Geotechnical Earthworks Letter

Project Reference: 19103

EARTHWORKS DESIGN REVIEW

Onoke Heights, 67 Dip Road, Kamo, Whangarei

DRAWING TITLE
Cross section location plan

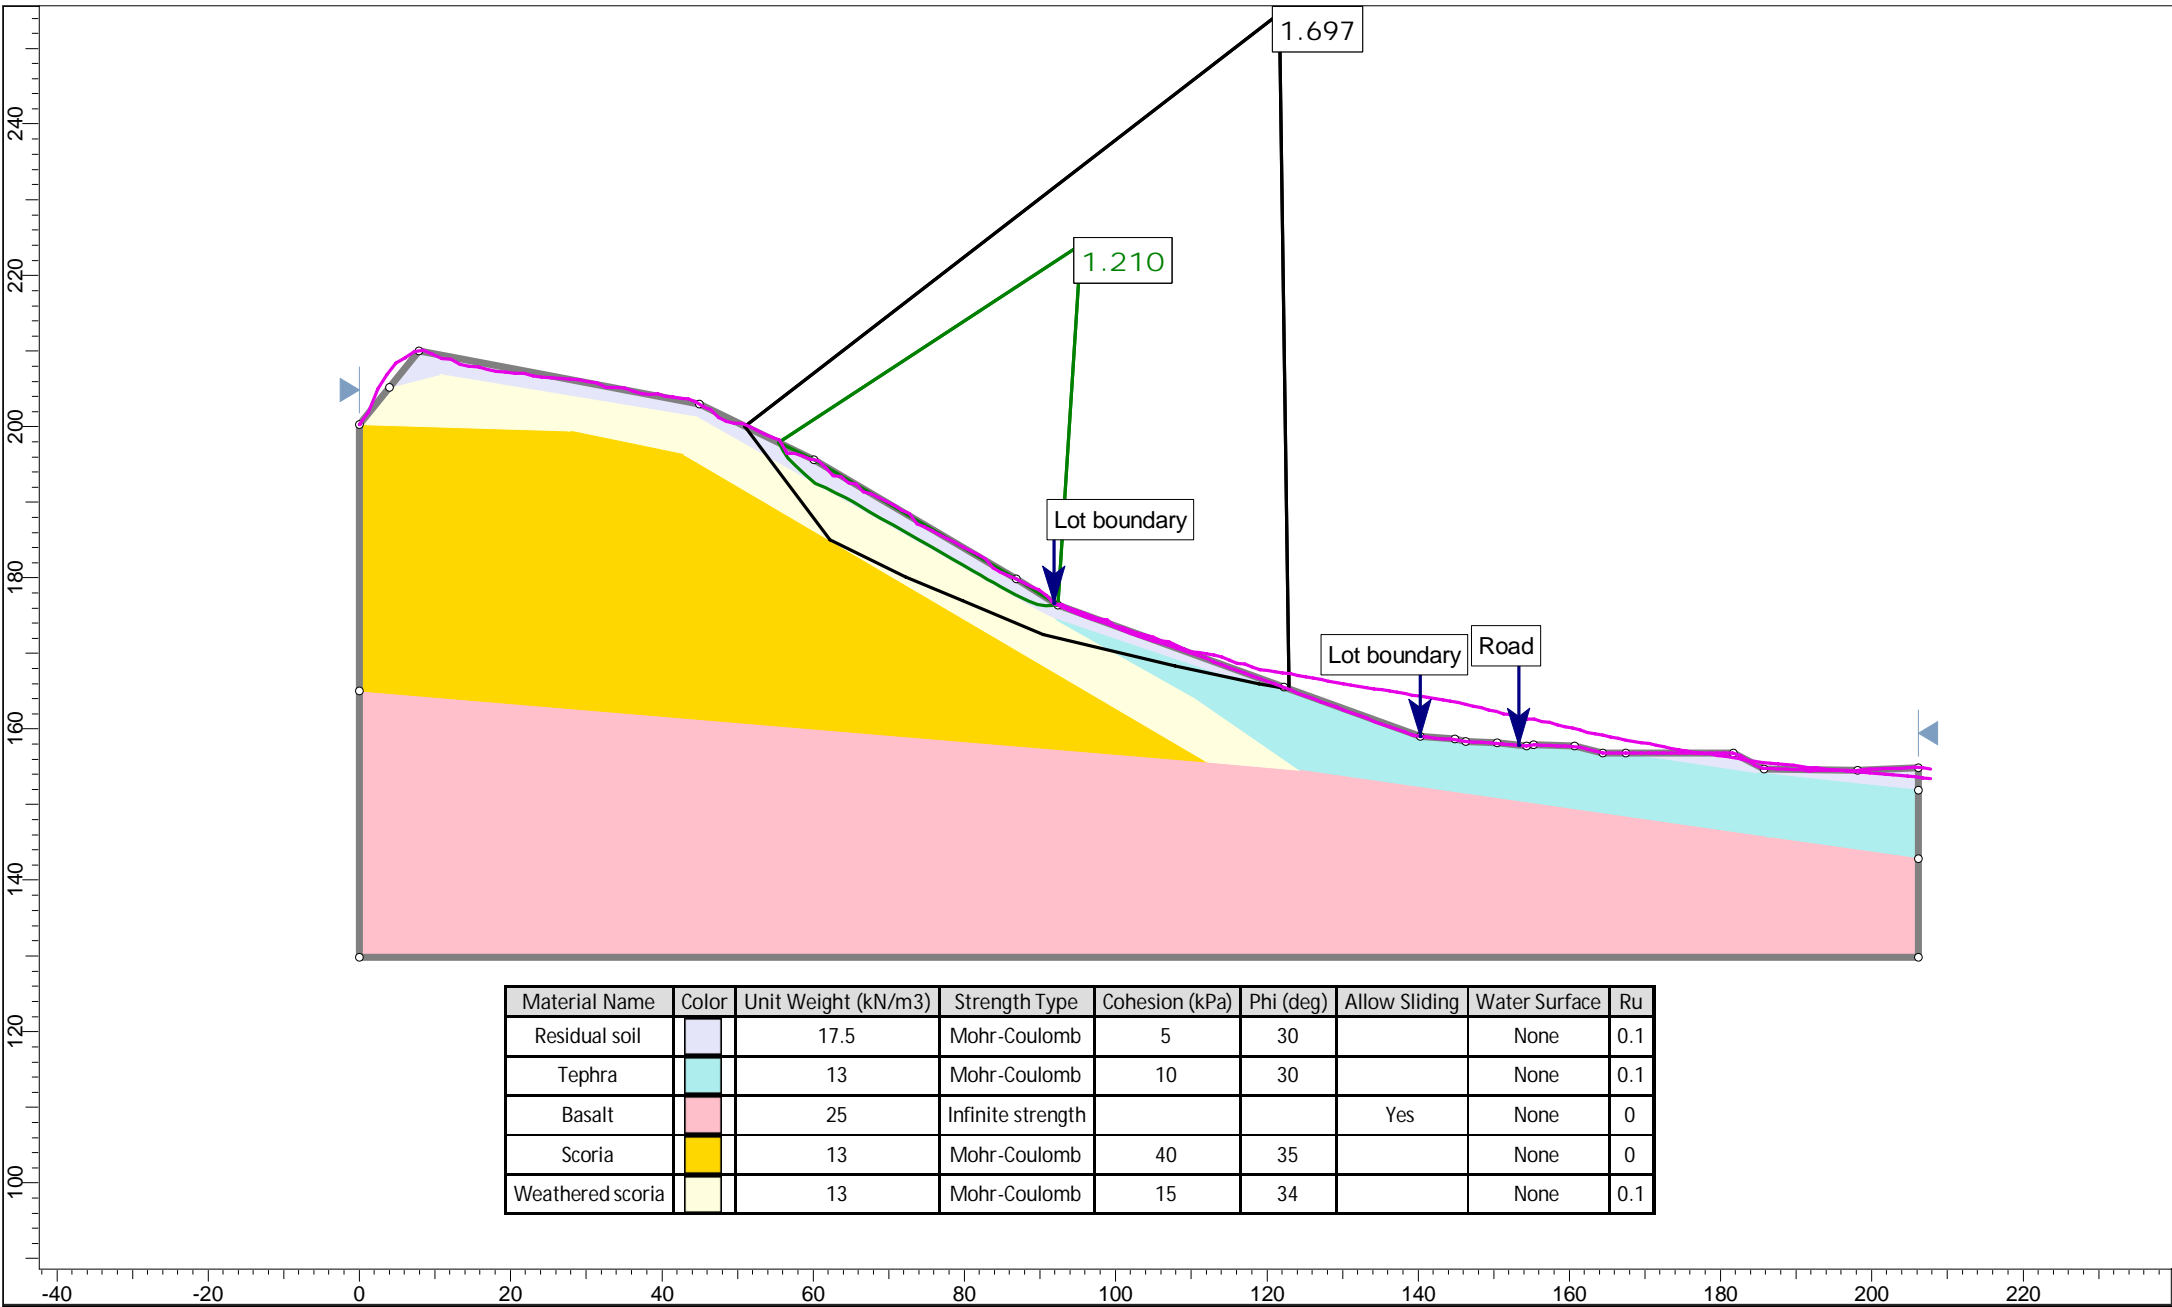
Stability analysis has been undertaken assess the stability of this slope and the proposed earthworks. The earthworks generally comprise significant down-cutting at the lower edge of the slope, to form the road. This cut will then be battered back to natural ground level towards the top edge of the sites.

The proposed cut is deepest at the south-western boundaries of Lots 88, 89 and 90, at up to approximately 5m depth. The sites are battered back from this edge at up to 1V:2.7H (20°).

The slope was found to be stable in the design case with the proposed cut, with the factor of safety for failures through the slope being >1.7 . The existing design of these lots is therefore considered appropriate.

It was found that any significant steepening of the cut slope, and in particularly any deep cuts (i.e. an unsupported cut for the dwelling) would result in potential instability from the reserve land above the slope. As a result specific assessment and design would be required for any future dwellings on these sites. It is generally expected that the sites will be suitable for suspended pole houses or multistorey houses cut into the slope with retaining. At the design grade some minor cuts will be required to gain access into the sites. Cuts for access are likely to also require retaining.
